No. EL/3.2.61/Gen.

**MODIFICATION SHEET NO. RDSO/2006/EL/MS/0345 (REV. '0'), MAY'06**

Standardisation of earthing switch arrangement on 3-phase locomotives to make interchangeable of various makes of VCBs between single and 3-phase locomotives.

REF.	SCALENTS	APPD BY:-
EXISTING ARRANGEMENT OF 3 PH LOCOMOTIVE FIRST ISSUED		FOR DG
FOR VCB (OF SECHERON DESIGN)		SUPERSEDS
& EARTH SWITCH (OF SECHERON DESIGN)		SUPERSEDED BY
RDSO ELECT. DTE. SKEL-4704

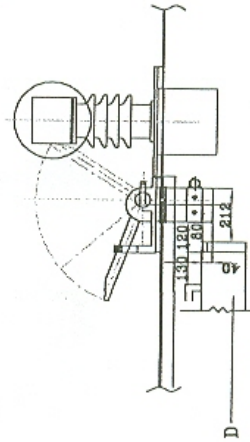
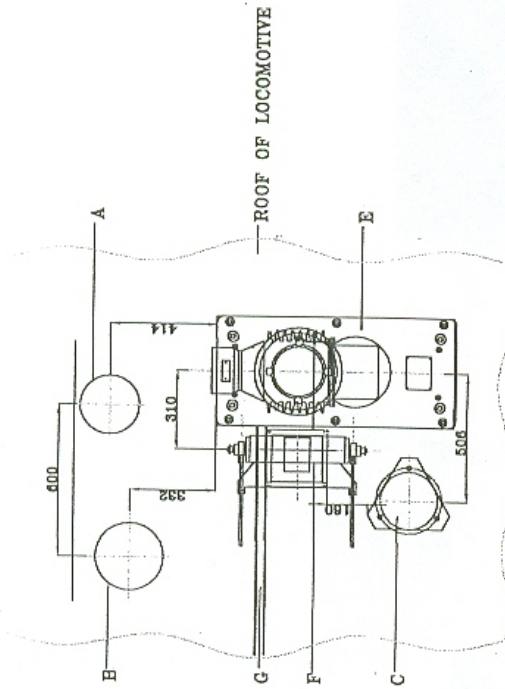
Existing arrangement of 3-phase locomotives for Secheron design circuit breaker and earthing switch is shown in enclosed drg, no.SKEL-4704. In this arrangement the moving blades of earthing switch are engaged with contact clips directly attached with the horizontal insulator of VCB.

REF.	SCALE:NTS	APPR. BY:-
		(Signature) FOR DG
NEW ARRANGEMENT OF 3 PH LOCOMOTIVE FOR FIRST ISSUED		
VCB (OF SECHERON/AREVA/BIECO DESIGN)		
& EARTH SWITCH OF SECHERON DESIGN		
SUPERSEDS		
RDSO ELECT. DTE. SKEL-4706		
SUPERSEDED BY

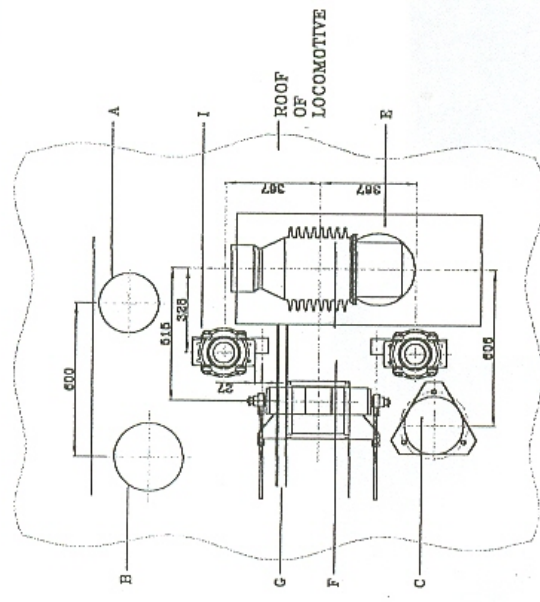
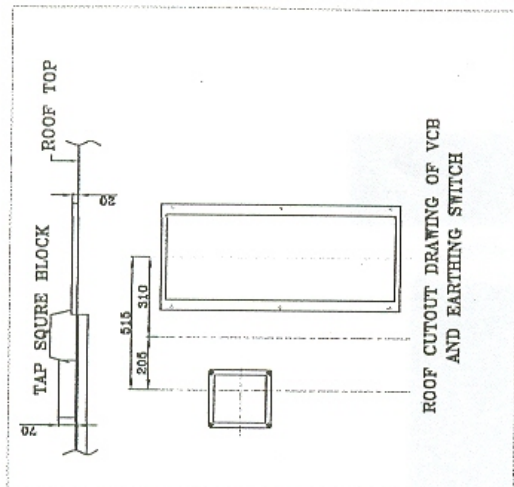
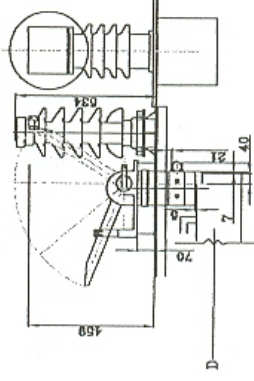
- 2.3 For standardisation of the earthing switch arrangement on 3-phase locomotives similar to the one already in use on conventional locomotives, the existing HOM has to be shifted by 205 mm (Details available in drg. No.SKEL-4706) with increased mounting collar height by 70 mm from loco roof. With provision of additional 02 nos roof insulators with attached contact clips arrangement to receive moving blades of HOM, the interchangeability is achieved and VCBs of any make can be fitted on 3-phase locomotives to gain advantages of ease in maintenance, inventory control and cost competition.

- i) Earthing switch cut out is shifted by 205mm as shown in the drg.No. SKEL - 4706.
- ii) Two additional roof insulators conforming CLW drg. No. CLW/ES/SK-2/AC/I-1,ALT.H are to be erected to receive earth switch contacts. Mounting arrangement of these two insulators shall be same as in conventional locomotives.
- iii) For mounting two additional insulators, surge arrester ( C ) is to be shifted to side by 100mm.
- iv) The height of square base plate for mounting earth switch is to be increased from existing 20 mm to 70 mm from loco roof.
- v) Existing exposed cut out to be sealed properly.
- vi) Two insulators mounted on the roof shall be connected to pantograph and bushing line by flexible connections.

- 1 : EARTH SWITCH CUTOUT IS SHIFED TO SIDE BY 205 mm
- 2 : TWO INSULATORS (CLW/TS/SE-2/AC/1-1-ALT-H) B : P.T. ADDED TO RECEIVED EARTH SWITCH CONTACTS
- 3 : FOR SETTING UP INSULATORS SURGE ARRESTOR 'C' IS SHIFED BY 100 mm TO SIDE.
- 4 : HEIGHT OF SQUARE BASE PLATE FOR MOUNTING EARTH SWITCH TO BE INCREASED FROM 20 mm TO 70 mm FROM ROOF
